**ENGINE FUEL AND CONTROL - MAIN ENGINE CONTROL (MEC) - CDP
BELLOWS ASSEMBLY INSPECTION**

SUMMARY: This service bulletin introduces a CDP bellows assembly check.

Subject: *Service Bulletin (SB) 83212-73-023, Original Issue*

Figure 1 - CDP Bellows Assembly Check
(Sheet 1 of 1)

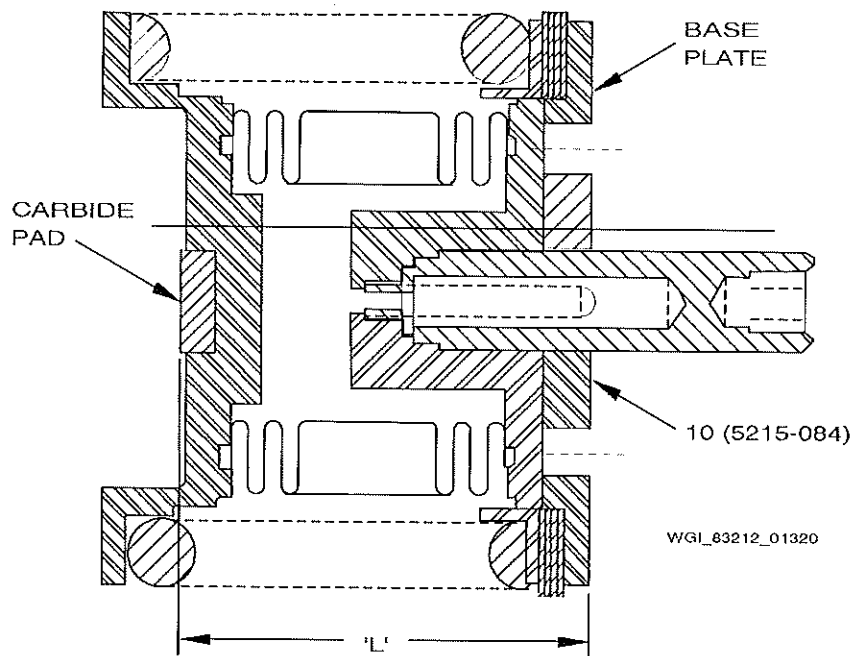
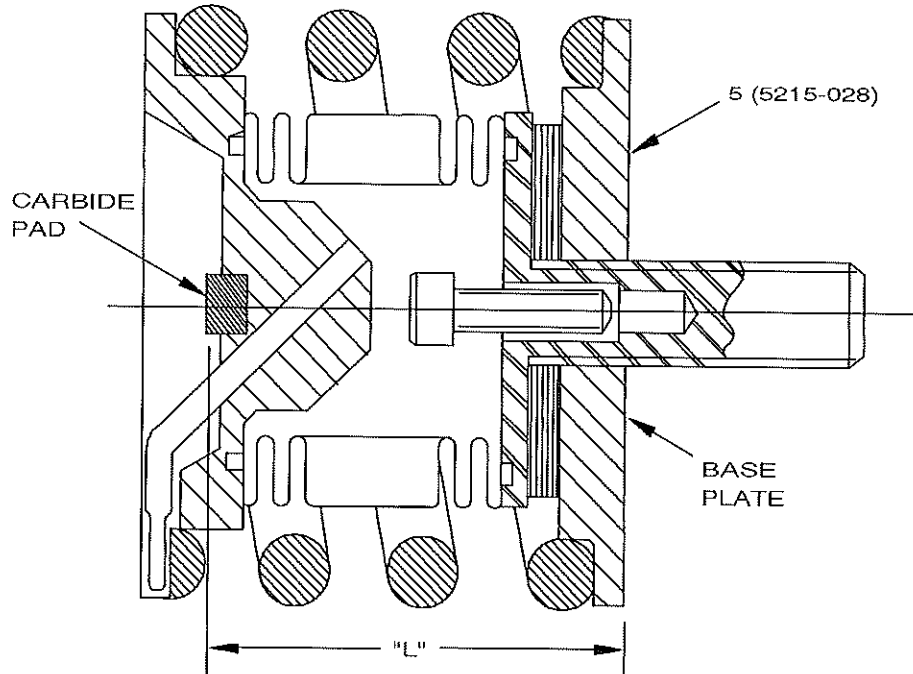
- (1) Measure bellows assembly (5 or 10, Figure 1) length "L" from surface of base plate to top of carbide pad (see Figure 1). Compare measured length "L" to dimension "L" marked on the bellows assembly (5 or 10) end. If dimensions are different by more than 0.003 inch (0,08 mm), replace the bellows assembly (5 or 10). Bellows assembly (5) manufactured prior to December 1999 and bellows assembly (10) manufactured prior to January 1993 are not marked with an "L" dimension. Due to the age of these unmarked parts in addition to the lack of a length reference, these bellows assemblies (5 or 10) shall be replaced.

Figure 2 - CDP Bellows Assembly Check
(Sheet 1 of 1)

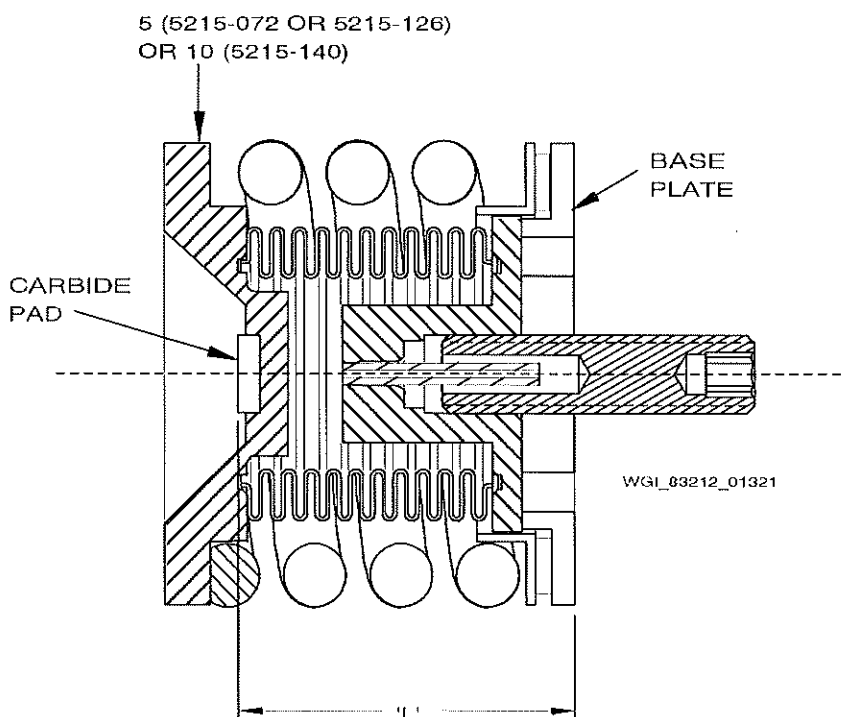
- (1) Measure bellows assembly (5 or 10, Figure 2) length "L" from surface of base plate to top of carbide pad (see Figure 2). Compare measured length "L" to dimension "L" marked on the bellows assembly (5 or 10) end. If dimensions are different by more than 0.003 inch (0,08 mm), replace the bellows assembly (5 or 10). Bellows assembly (5) manufactured prior to December 1999 are not marked with an "L" dimension. Due to the age of these unmarked parts in addition to the lack of a length reference, these bellows assembly (5) shall be replaced. Bellows assembly (5) manufactured after 1999 have a length dimension marked, but the dimension is not identified with a letter. Do not use the dimension identified with "H". Beginning in 2001, the length dimension on bellows assembly (10) has been identified with the letter "L".

Figure 3 - CDP Bellows Assembly Check
(Sheet 1 of 1)

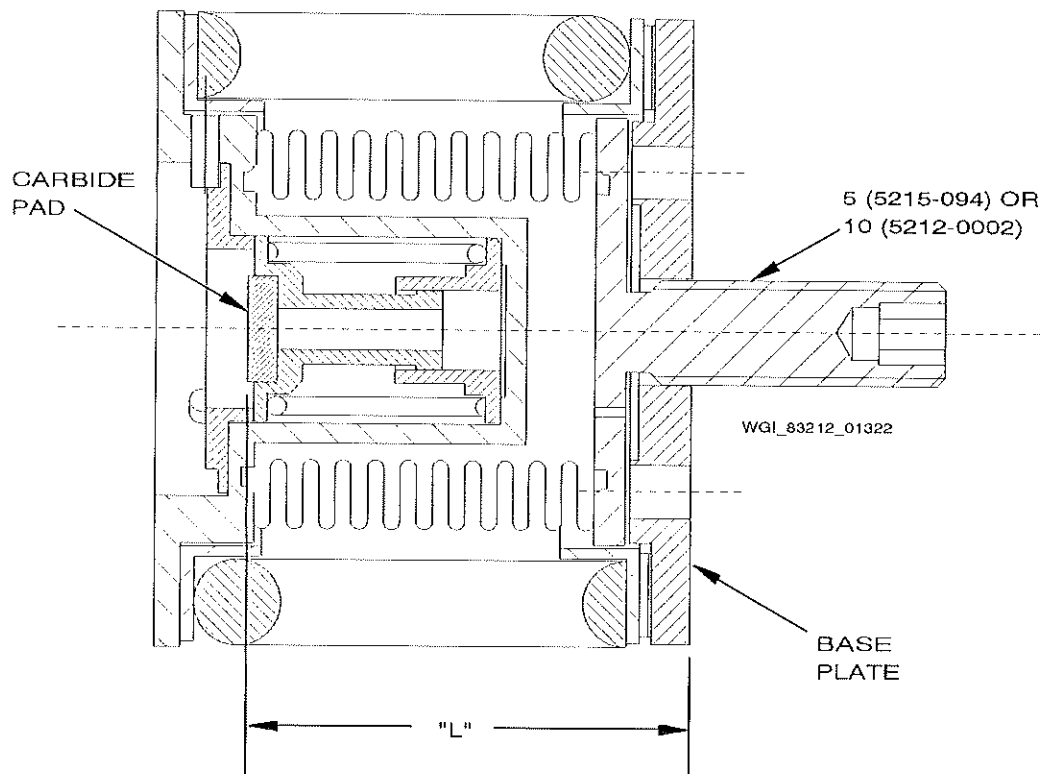
- (1) Measure bellows assembly (5 or 10, Figure 3) length "L" from surface of base plate to top of carbide pad (see Figure 3). Compare measured length "L" to dimension "L" marked on the bellows assembly (5 or 10) end. If dimensions are different by more than 0.003 inch (0,08 mm), replace the bellows assembly (5 or 10). Bellows assembly (5) manufactured prior to January 1993 are not marked with an "L" dimension. Due to the age of these unmarked parts in addition to the lack of a length reference, these bellows assemblies (5) shall be replaced.

Figure 4 - CDP Bellows Assembly Check
(Sheet 1 of 1)

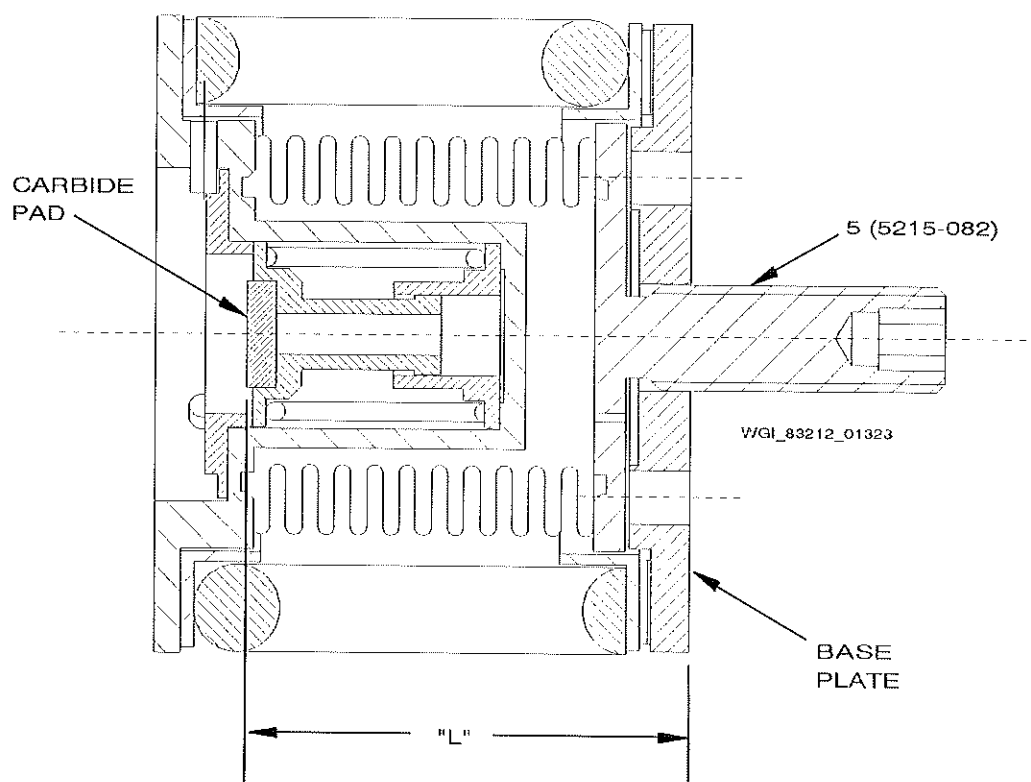
- (1) Measure bellows assembly (5, Figure 4) length "L" from surface of base plate to top of carbide pad (see Figure 4). Compare measured length "L" to dimension "L" marked on the bellows assembly (5) end. If dimensions are different by more than 0.003 inch (0,08 mm), replace the bellows assembly (5). Bellows assembly (5) manufactured prior to December 1999 are not marked with an "L" dimension. Due to the age of these unmarked parts in addition to the lack of a length reference, these bellows assemblies (5) shall be replaced. Bellows assembly (5) manufactured after 1999 have a length dimension marked, but the dimension is not identified with a letter. Do not use the dimension identified with "H".
